MANCHESTER-BY-THE-SEA

June 22, 2021

RE: Proposed 40B – The Sanctuary at Manchester-by-the-Sea, MH ID No. 1116

Site Driveway at School Street – Sight Distance

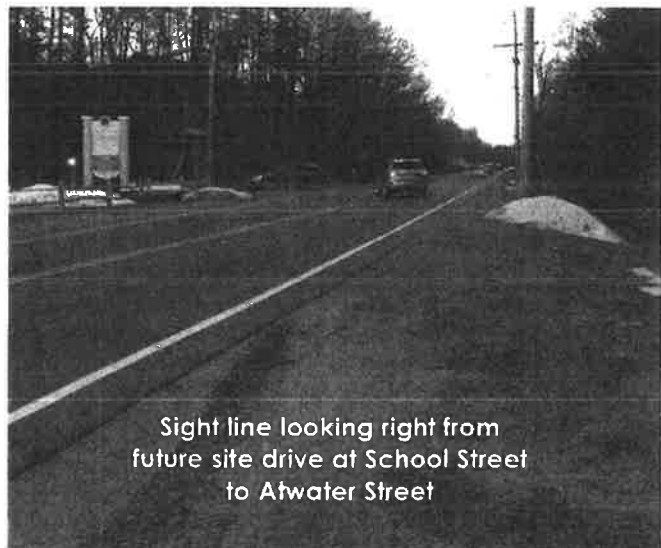
Sight line looking left from
future site drive at School Street

Sight line looking right from
future site drive at School Street
to Atwater Street

PARKING LEVEL PLAN

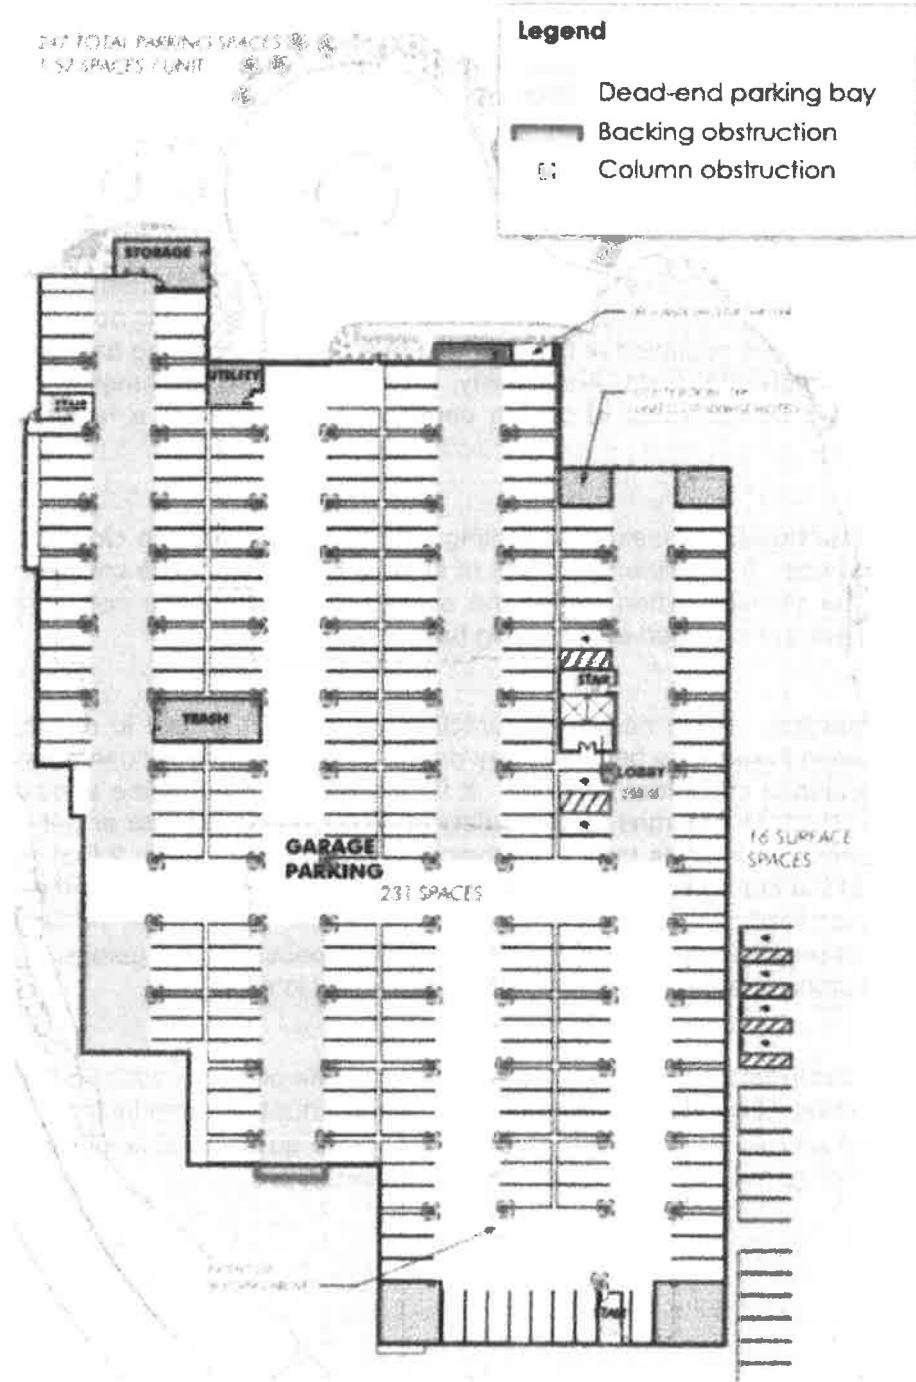
Augmented by an illustration on the next page, comments below pertain to circulation issues that warrant some discussion with the Applicant for safe garage operations, in order of importance:

- **Dead-end parking bays.** The site plan proposes a total of five 'dead-end' parking bays. Such dead-end bays are problematic and are not recommended. It is not always possible to see whether a space is occupied at the entrance to a dead end parking bay, even if all spaces are assigned to individual units. Additionally, if for any reason, an emergency vehicle must enter the garage, the absence of driving continuity could present a hazardous circulation condition.

- **Backing obstructions.** At least four parking spaces are located too close to walls for safe backing maneuvers. If possible, an indent of at least 6 feet should be considered to create a backing area for vehicles when exiting the spaces in question. We note that this issue is eliminated if there are no 'dead-end' parking bays.

- **Structural columns.** While not always practical to do so, it is best to minimize the use of structural columns in garages because they create safety hazards for users adjacent to them and a high incidence of 'fender-benders'. It is necessary to add some additional clearance areas around structural columns for the safety of motorists driving into or out of their spaces and walking between vehicles to or from their parking spaces, usually 2 feet additional width on each side of the column or, essentially a total envelope of 5 feet around the columns. The garage plan submitted calls for the installation of more than 80 columns that will directly affect the users of approximately 160 of the 231 parking spaces in the garage. The envelope around the columns seems to be 2 feet rather than 5 feet in width.

EXHIBIT II

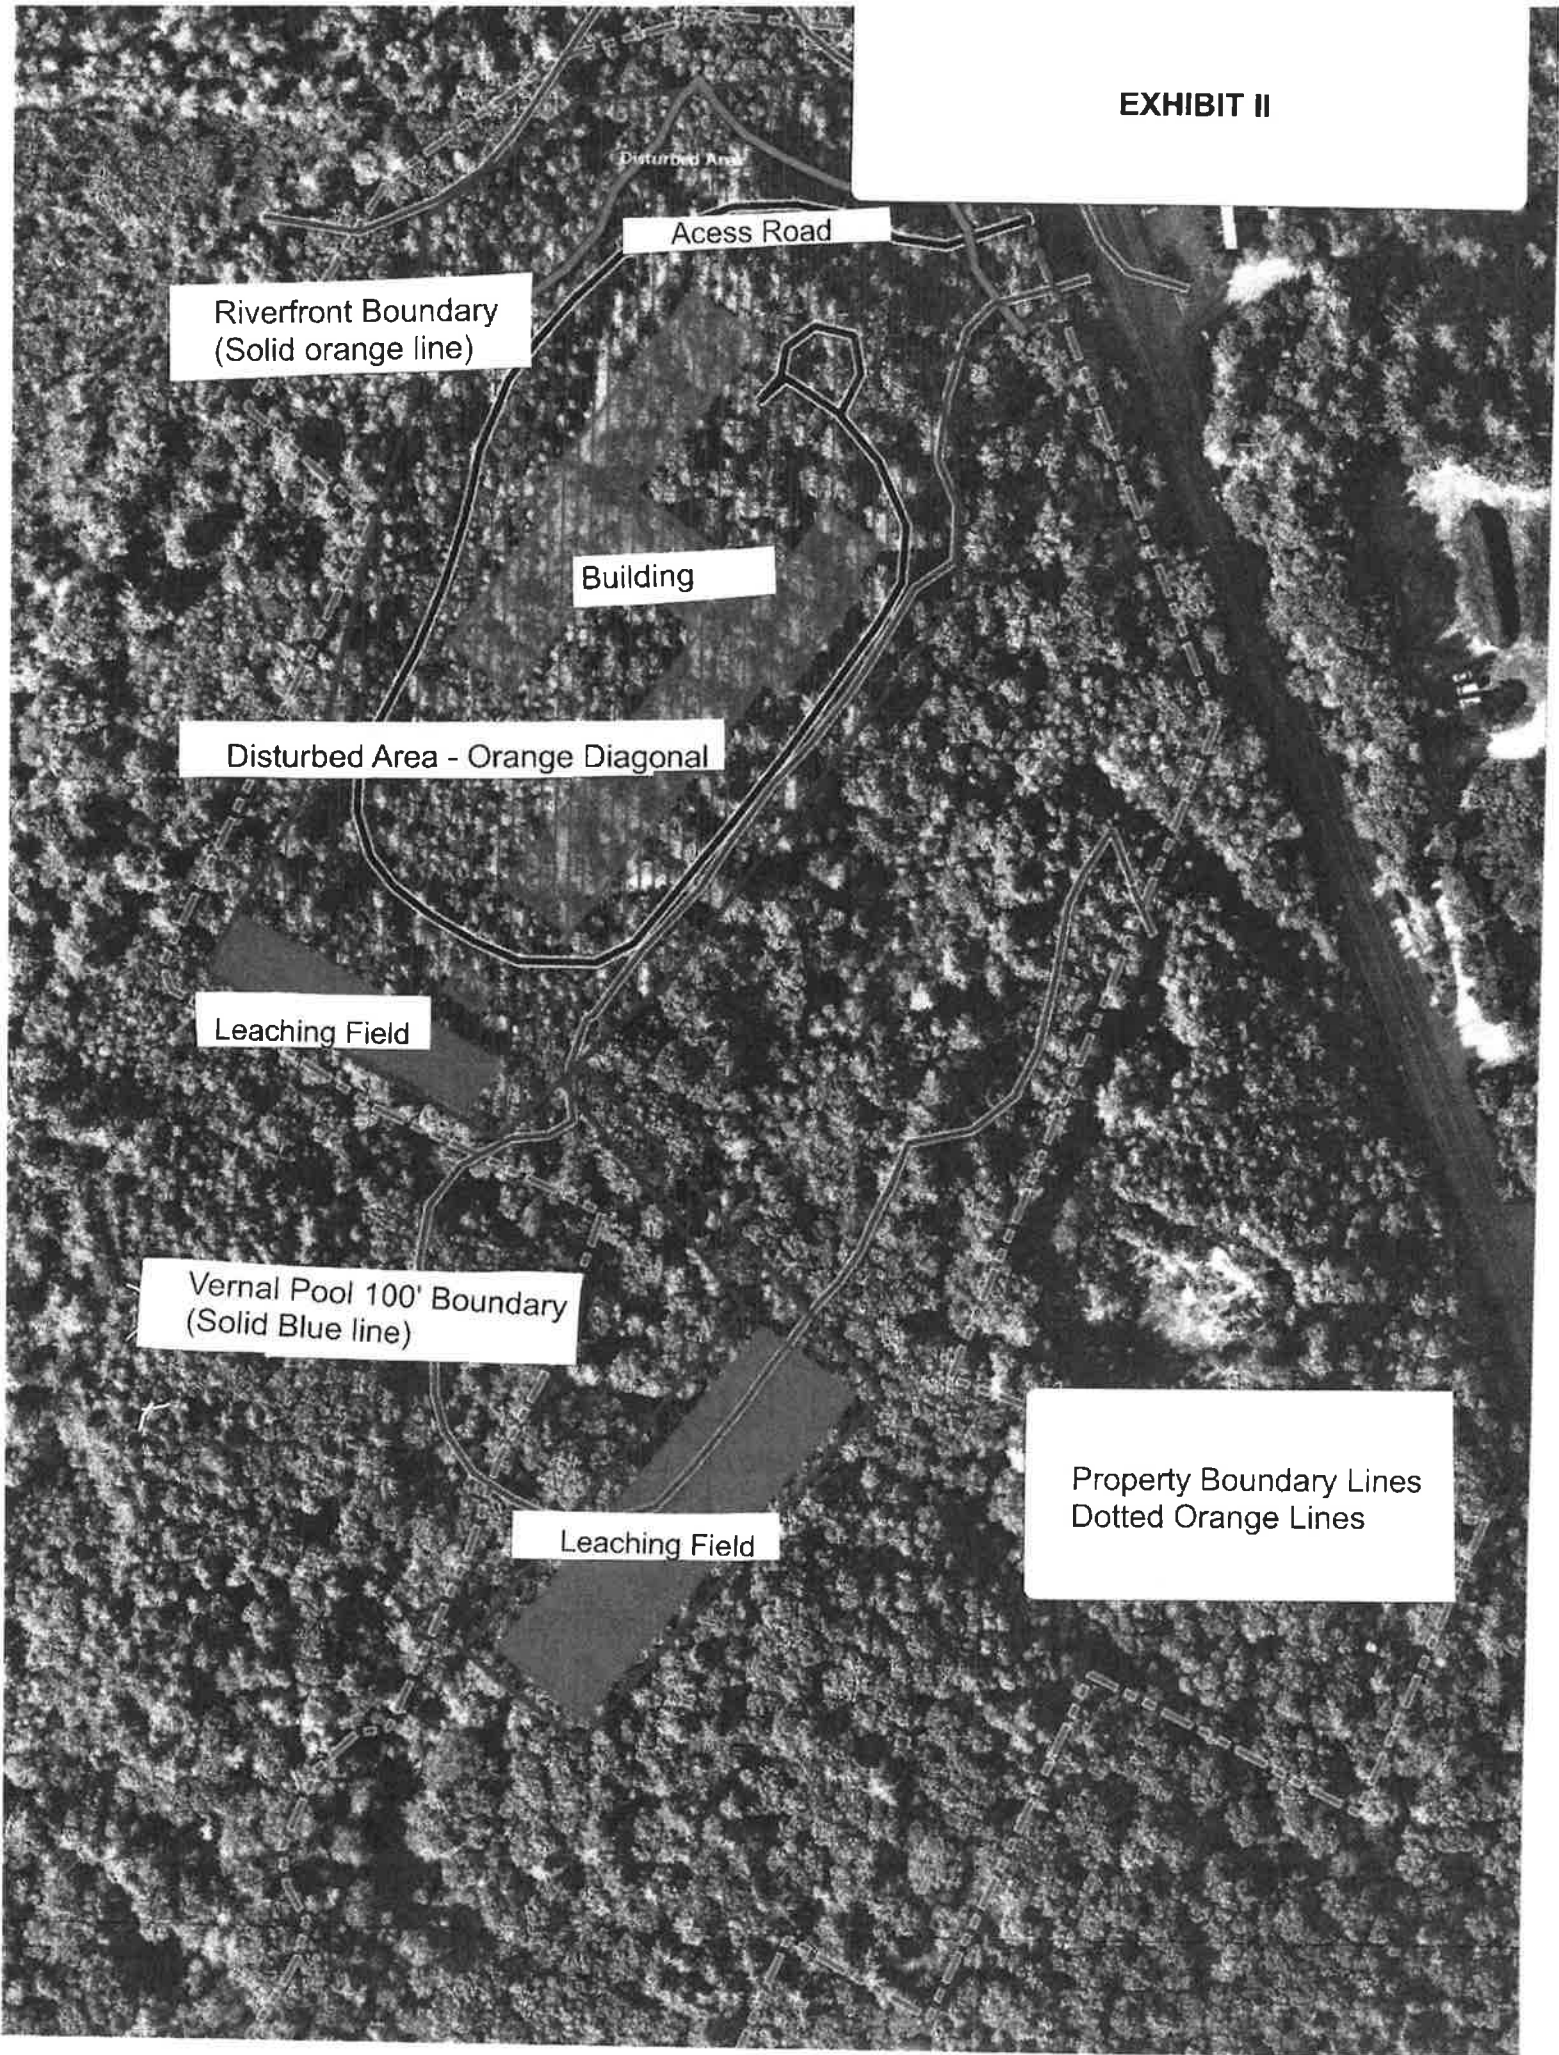
- The subject site is surrounded on all sides by rivers or wetlands. Storm water runoff is a major concern. During construction, site plans submitted to the Town indicate that the height of the site will be reduced by 40 feet, which can only be accomplished by blasting into the largely granite hill. After construction has been completed, much of the vegetation surrounding the buildings will have been removed. To date, no Storm Water Management Plan has been submitted to the Town for its review. The two catch basins located at the intersection of the access road and School Street, within the riverfront boundary of the Sawmill Brook, are likely insufficient to prevent runoff on to School Street and critical water resources. Please see the attached Satellite image with project overlay attached as Exhibit II.
